From: WILLIFORD Dennis (AREVA) [Dennis.Williford@areva.com]
Sent: Wednesday, July 06, 2011 9:26 AM
To: Tesfaye, Getachew
Cc: BENNETT Kathy (AREVA); DELANO Karen (AREVA); ROMINE Judy (AREVA); RYAN Tom (AREVA)
Subject: Response to U.S. EPR Design Certification Application RAI No. 371, FSAR Ch. 3, Supplement 22
Attachments: RAI 371 Supplement 22 Response US EPR DC.pdf

The attached file, "RAI 371 Supplement 22 Response US EPR DC.pdf" provides a technically correct and complete final response to Question 03.07.01-28. Appended to this file are the affected pages of the U.S. EPR Final Safety Analysis Report in redline-strikeout format which support the response to RAI 371 Question 03.07.01-28.

Figure 03.07.01-28-2—Example Strength Curve in Strong Axis for B-Line Systems Model B-104 Clip Angle with B-Line Systems B-22A Strut

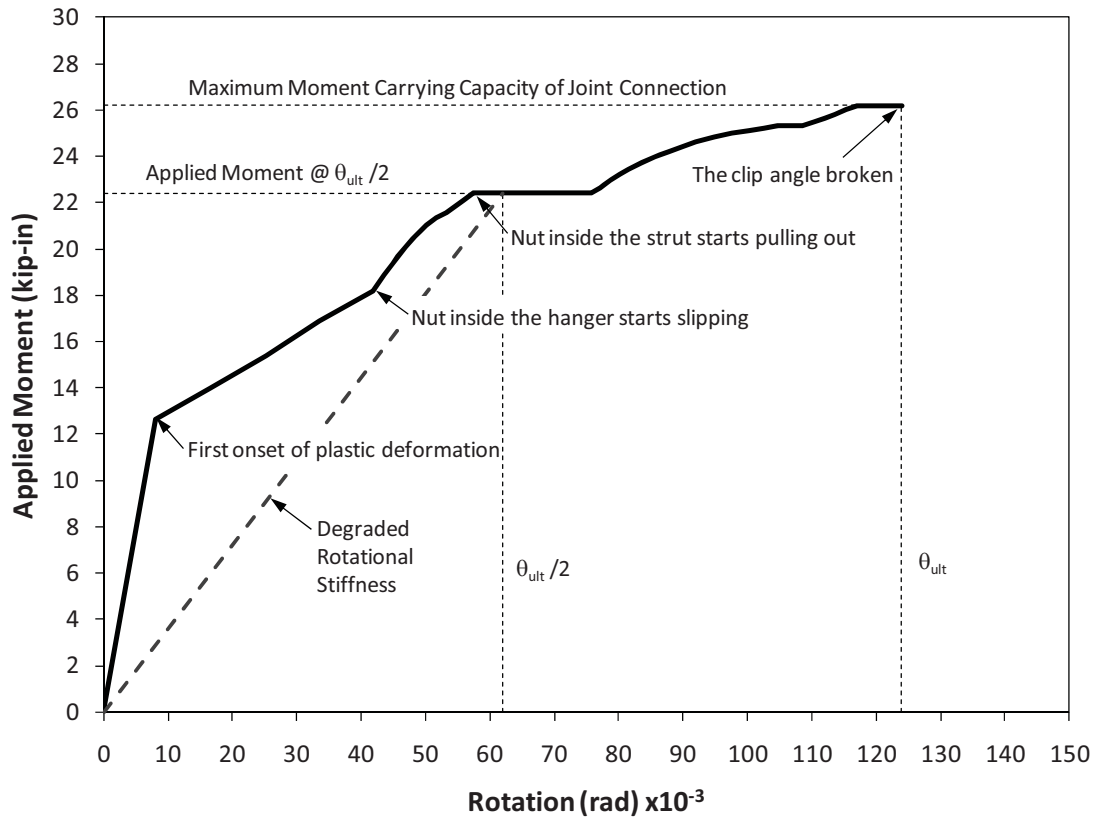
4. Describe how the damping values were determined in the test program.
- B. The third paragraph of the response makes a reference to Figure 03.07.01-23-1 which is supposed to show analytical and computer models that were developed and calibrated to evaluate the cable tray systems that were experimentally tested. The analytical and computer models were not provided in the response. The applicant is requested to provide these models and describe how they were calibrated to evaluate the cable tray systems.

For the transverse direction, degraded rotational spring stiffness representing the rotational behavior of a strut and clip angle support connection is obtained from moment versus rotation curves (also referred to as “strength” or “backbone” curves) determined from static connection load tests. Figure 03.07.01-28-1 shows connection types that were load tested. The methodology used for these connection load tests is documented in Reference 1. An example of a typical strength curve obtained from a strut connection load test is shown in Figure 03.07.01-28-2. In Figure 03.07.01-28-2, the applied moment is plotted against single amplitude rotation of the connection. During the connection load test, rotation amplitude was increased linearly from zero to the rotation at failure. The degraded rotational spring constant for a particular strut connection is defined as the slope of the line from the origin to the point on the strength curve corresponding to one-half the maximum tested rotation of the connection (see the dashed line in Figure 03.07.01-28-2). System frequency analyses based on this method of defining degraded rotational spring stiffness correlated well with fundamental frequency results obtained from cycles of seismic testing after connection softening occurred and this results in a conservative estimate of the cable tray system fundamental frequency. Although the degraded rotational stiffness shown in Figure 03.07.01-28-2 (slope of the dashed line) is obtained from a static connection load test, the adjustment in rotational stiffness is able to capture the connection flexibility after many cycles.

The localized nonlinearities associated with cable tray support connections are accounted for in models using degraded rotational spring constants (obtained from strength curves, such as Figure 03.07.01-28-2) to facilitate linear modeling of the cable tray system, and allow usage of linear methods of analysis. The calculated rotational demands of the connections are qualified against corresponding low-cycle fatigue tests. These tests, for various strut connection configurations, were performed at prescribed rotation amplitudes to verify that the connection can sustain stable hysteresis for a number of cycles equivalent to five operating basis earthquake (OBE) seismic events and one safe shutdown earthquake (SSE) seismic event, consistent with the criteria defined in U.S. EPR FSAR Tier 2, Section 3.7.3.2. The hysteresis curves developed during the connection load tests demonstrate stable hysteresis. Figure 03.07.01-28-3 shows hysteresis plots of a typical bolted clip angle connection for the first cycle of motion and for four different prescribed maximum rotation amplitudes. Figure 03.07.01-28-3 shows that plastic deformations near the support provide additional energy dissipation (area inside the hysteresis curves). This damping is in addition to the 15 percent (or greater) damping caused by friction between cables, and movement and bouncing of cables within the tray as a result of unyielding connections. Additional conservatism is provided. Further information on implementation of degraded rotational stiffness and low-cycle fatigue in the modeling and analysis process is provided in Part E of this response.

Figure 3.7.1-16—Damping Values for Cable Tray Systems

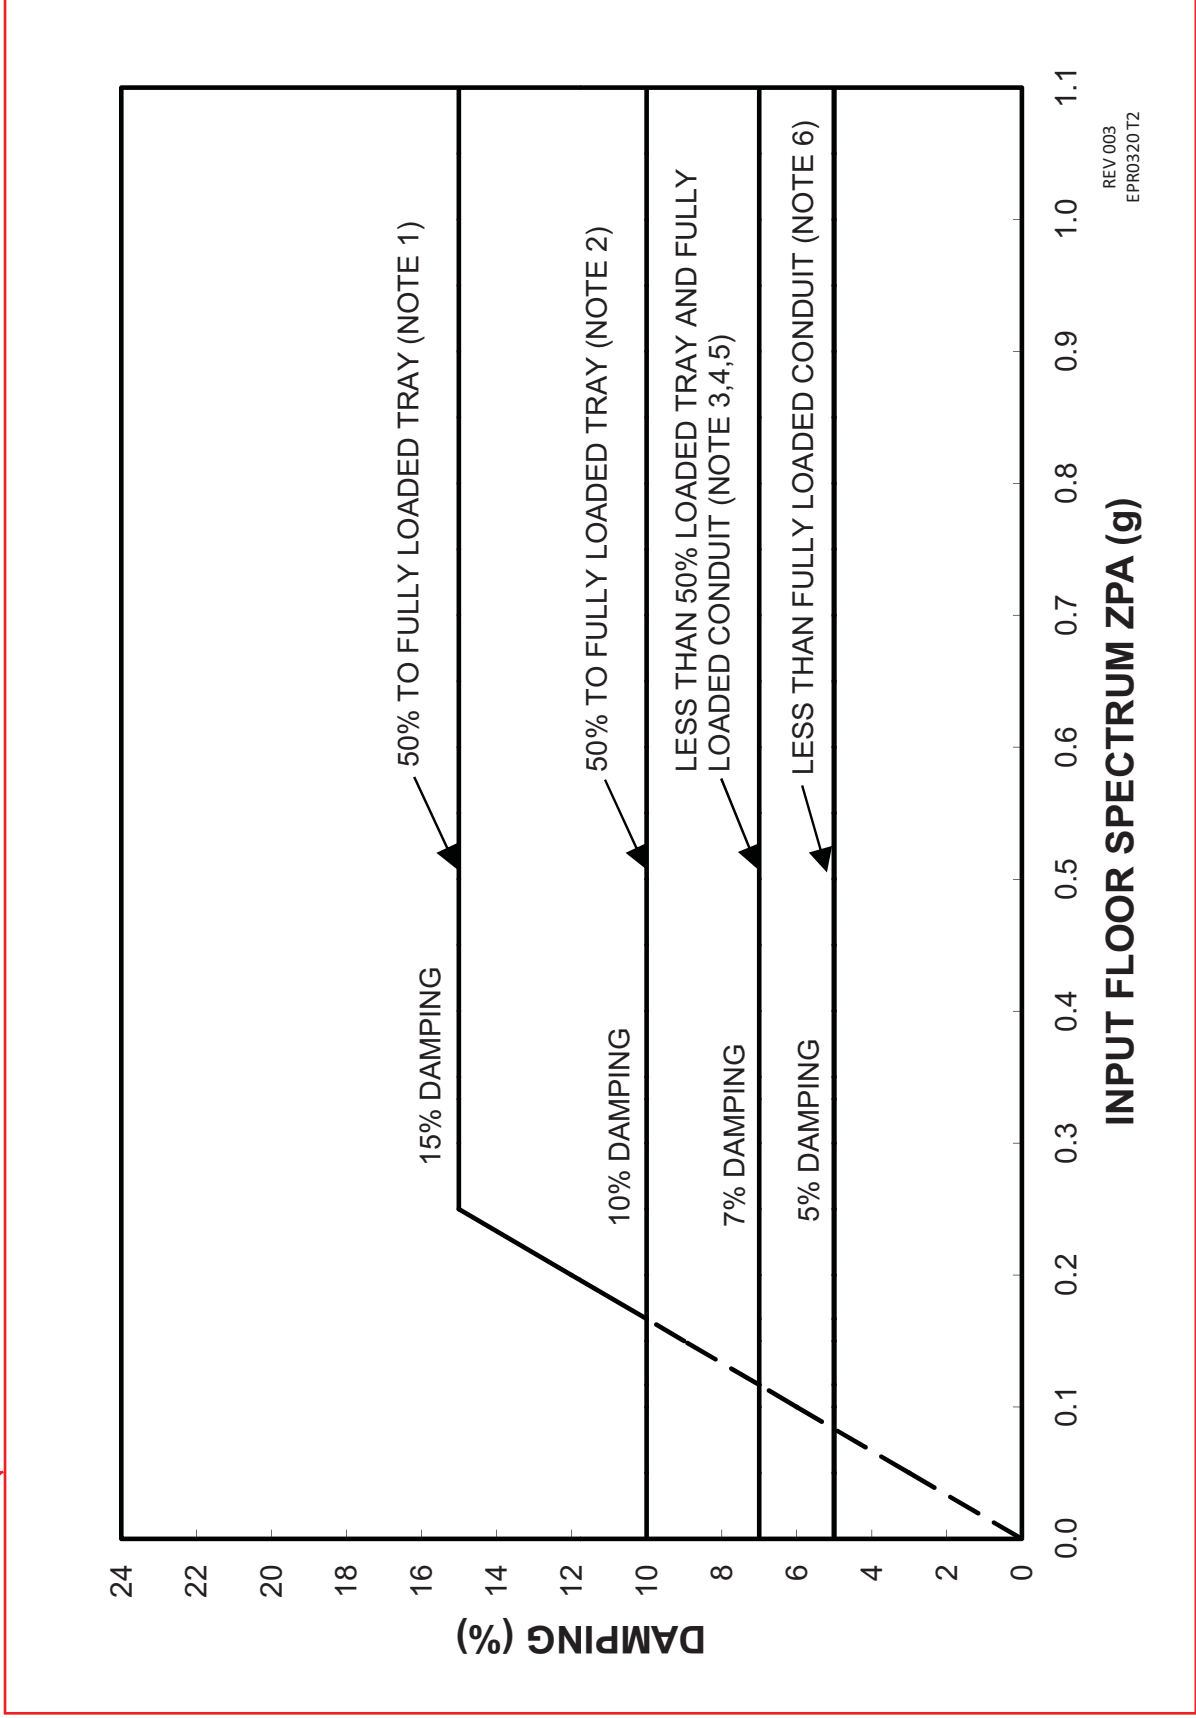
- D. Regarding note 2 in revised Figure 3.7.1-16, the applicant is requested to provide the criteria used for determining that the cable tray system is significantly different from those tested and thus require a damping value of 10 percent for tray greater than 50 percent loading. The criteria should be added to the FSAR.

5. Describe how three components of earthquake motion are considered and the responses combined for cable tray design.
- F. In the FSAR markup on page 3.7-15 it states in note 3.D that the selected damping value, i.e. 10 percent, is to be justified when cable loadings are less than 50 percent of the maximum. However, note 3.A states that 10 percent damping is to be used with maximum cable loadings. Note 3 to Figure 3.7.1-16 states that a damping value of 7 percent should be used for cable tray systems that are unloaded or loaded less than 50 percent while note 2 to the same figure states that for cable tray systems that are significantly different than those tested use a damping value of 10 percent for tray with greater than 50 percent loading. The applicant is requested to clear up the discrepancy between the notes in the table and the notes in the Figure regarding the use of 10 percent damping.

U.S. EPR FSAR Tier 2, Figure 3.7.1-16, Note 1 will be revised to state, “For cable tray systems, meeting the cable tray system similarity criteria in Table 3.7.1-7—Criteria for Cable Tray System Similarity with Bechtel-ANCO Test Program, a damping value of up to 15 percent in transverse direction only may be used for 50 percent to fully loaded tray subject to the following limitations.”

U.S. EPR FSAR Tier 2, Figure 3.7.1-16, Note 2 will be revised to state, “For cable tray systems that do not meet cable tray similarity criteria in Table 3.7.1-7—Criteria for Cable Tray System.

U.S. EPR FSAR Tier 2, Table 3.7.1-1 and Figure 3.7.1-16 will be revised to modify the damping value discrepancies. U.S. EPR FSAR Tier 2, Sections 3.7.1.2 and 3A.3.5 will also be revised to maintain consistency with U.S. EPR FSAR Tier 2, Table 3.7.1-1 and Figure 3.7.1-16.
